# ADDENDUM NO. 1

**October 18, 2022**

## **Additions and Renovations Eastridge Elementary School**

### **TO: ALL BIDDERS OF RECORD**

DRAWING NUMBER  
**A801A**

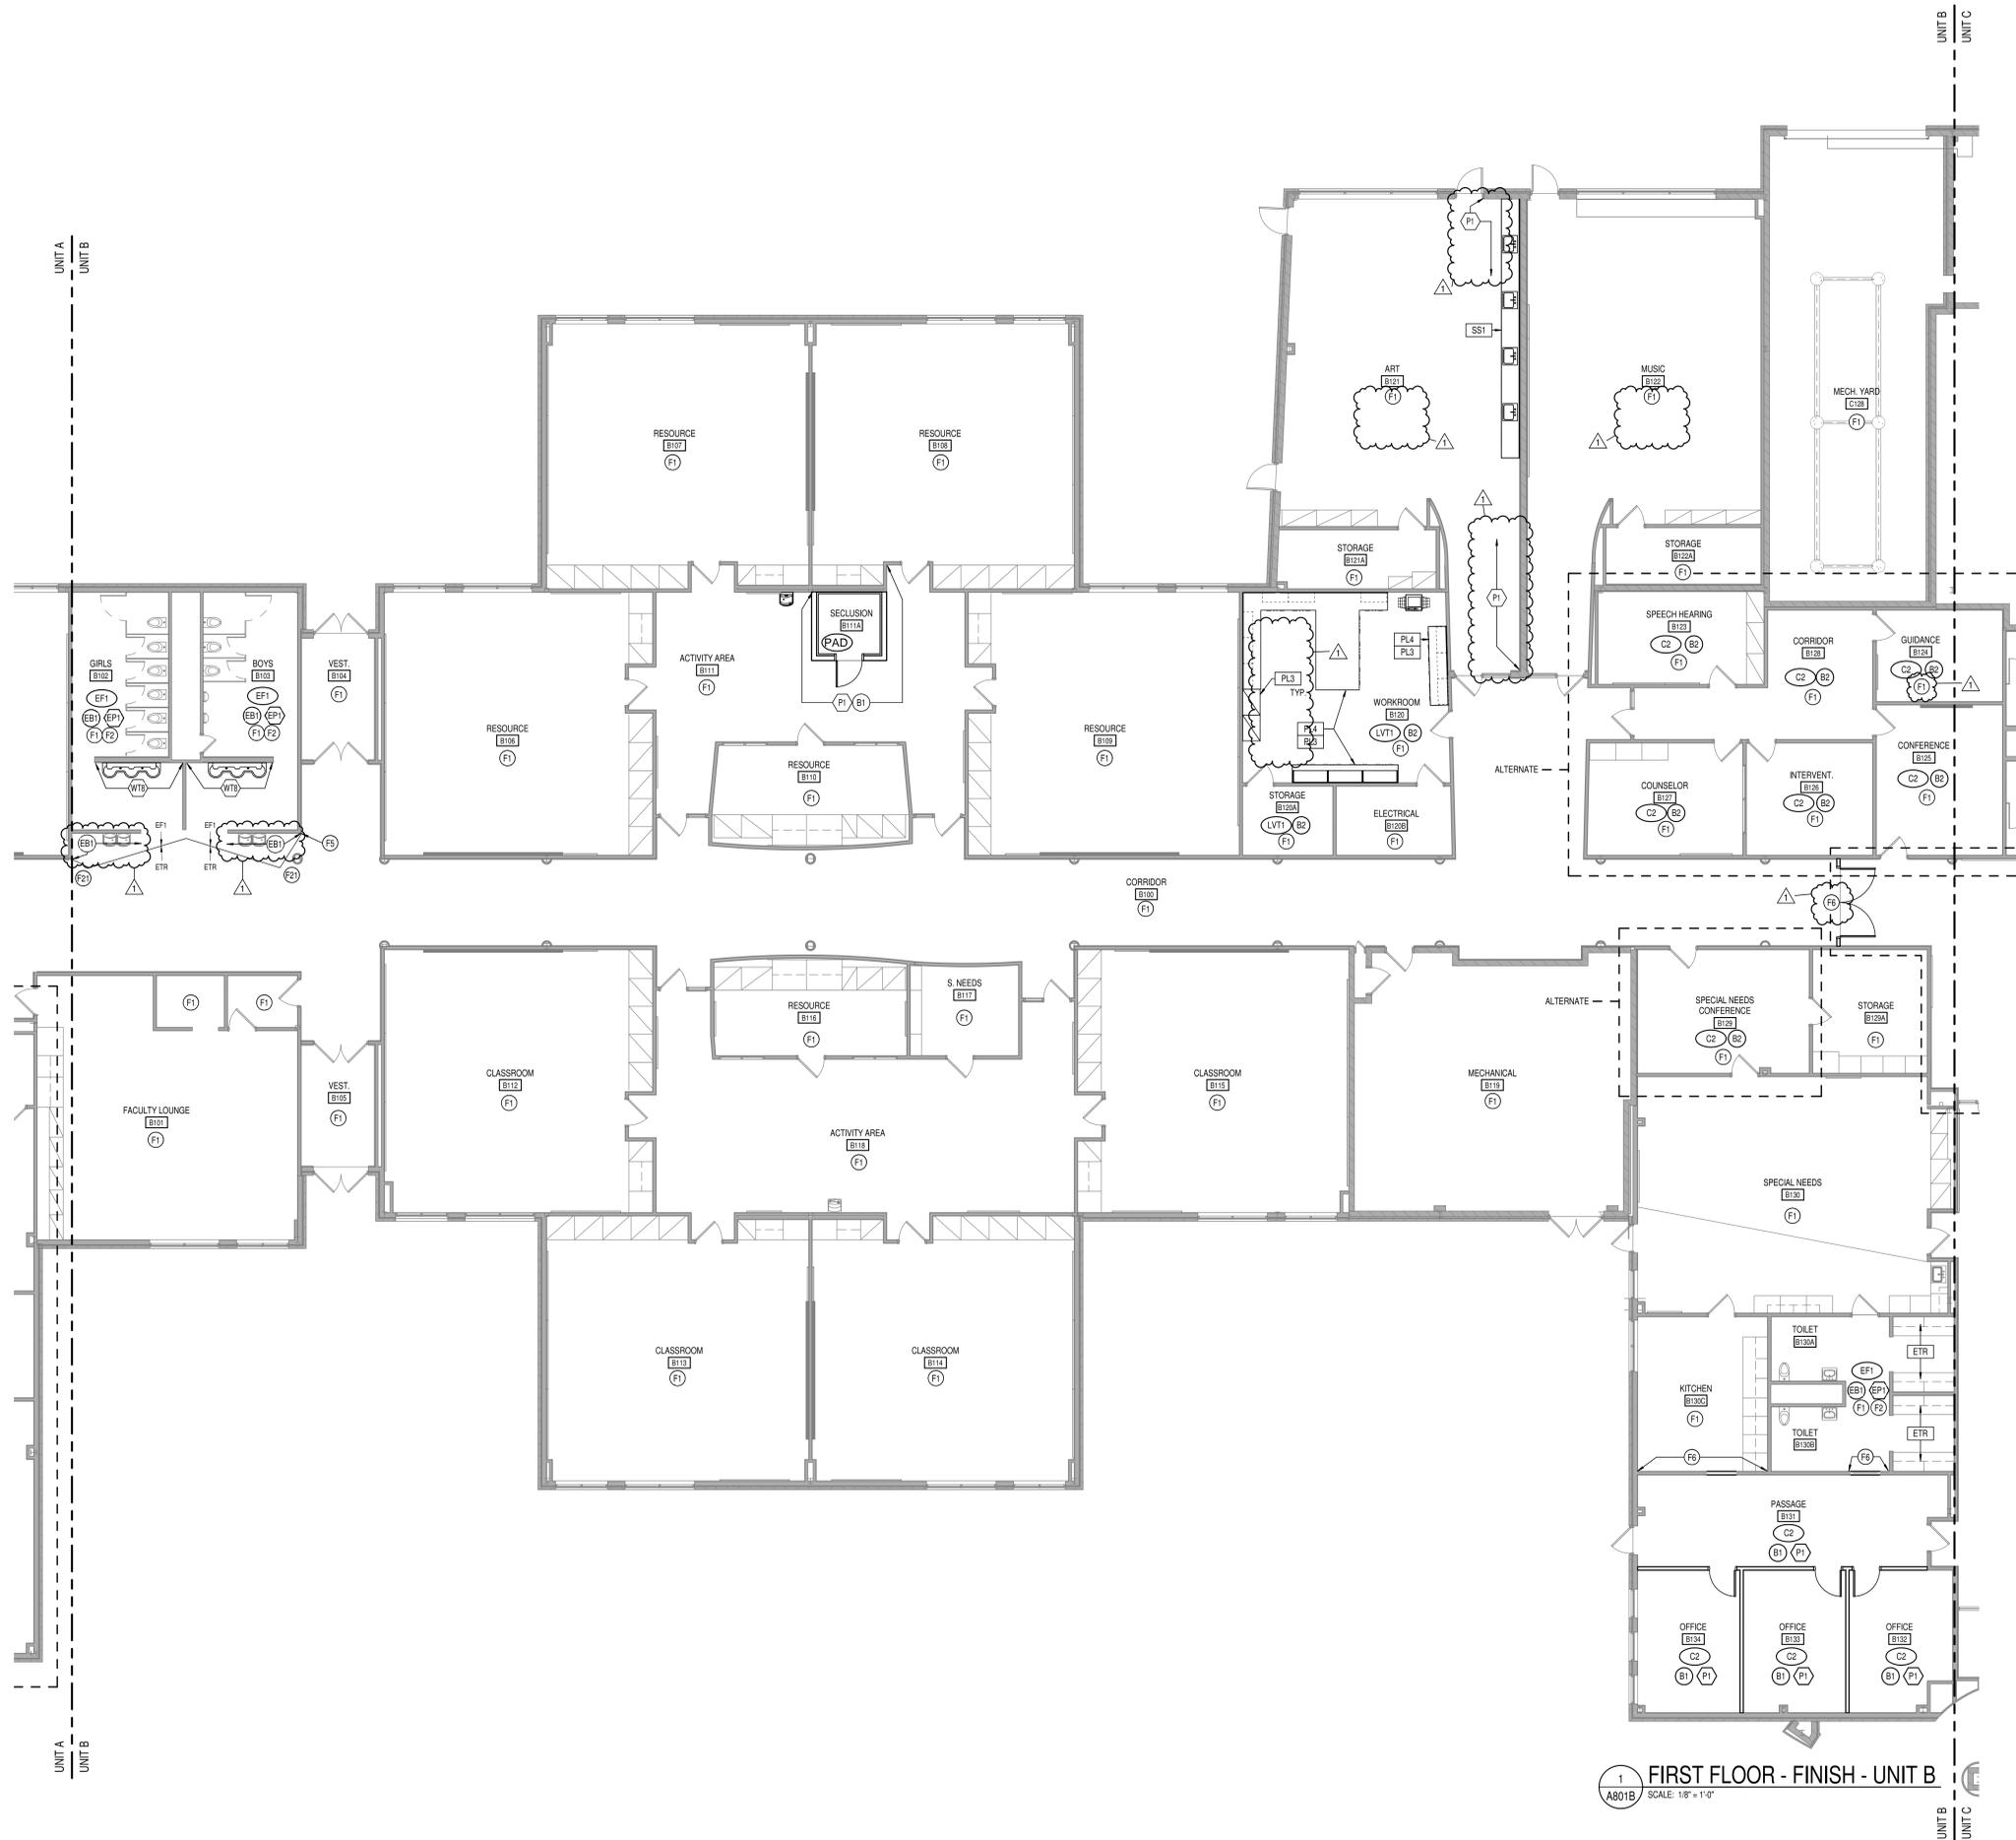
3.14 SHEET A801A – FIRST FLOOR FINISH PLAN – UNIT A

- A. Delete and replace entire sheet.
- B. Added finish tags EB1 outside of BOYS A115 and GIRLS A116.
- C. Added casework finish tags to MEDIA CENTER A121 reception desk.
- D. Added wall paint tag P1 to LIBRARIAN A121B

DRAWING NUMBER:  
**A801B**

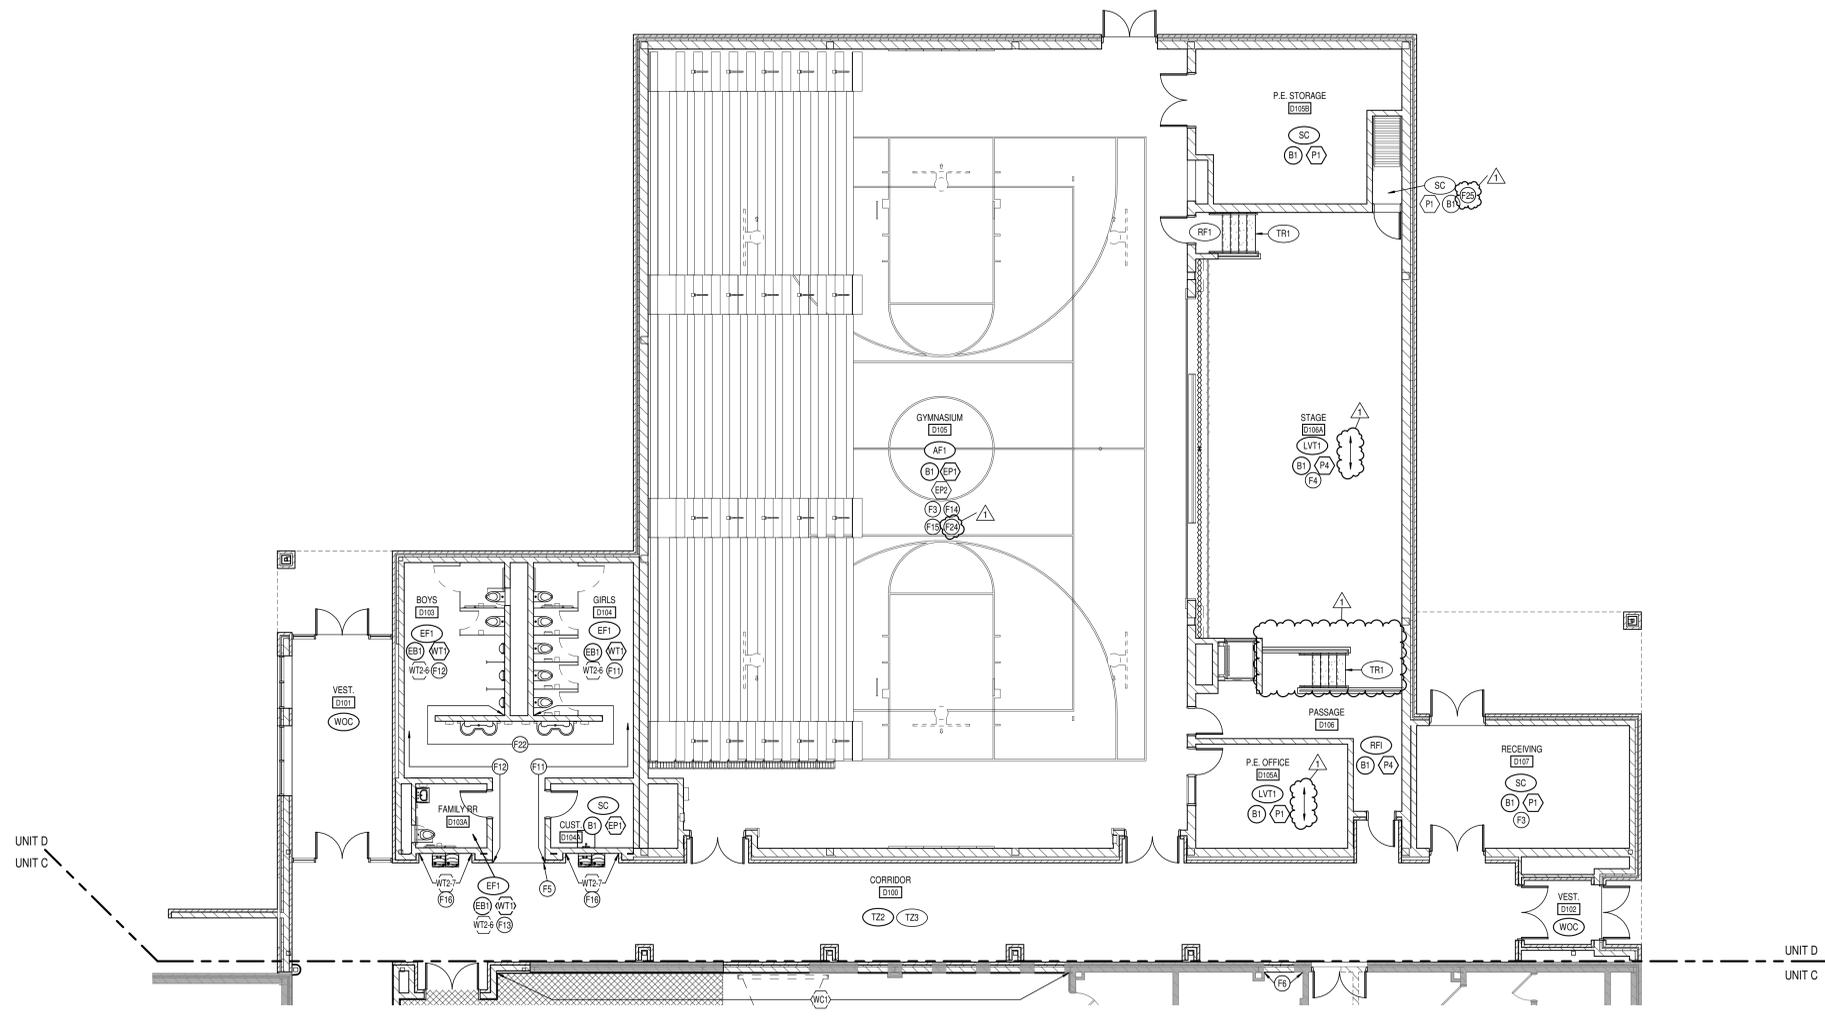
3.15 SHEET A801B – FIRST FLOOR FINISH PLAN – UNIT B

- A. Delete and replace entire sheet.
- B. Added finish tags EB1 outside of GIRLS B102 and BOYS B103.
- C. Revised casework finish tags in WORKROOM B120.
- D. Delete floor and base finish tags from ART B121 and MUSIC B122.

- E. Added wall paint tags P1 to ART B121.
- F. Added keyed finish note F1 to GUIDANCE B124.
- G. Added keyed finish note F6 to new cross-corridor door/wall in CORRIDOR B100.
- H. Seclusion Room B111A: provide manufacturers' standard floor padding system integral with wall padding system.
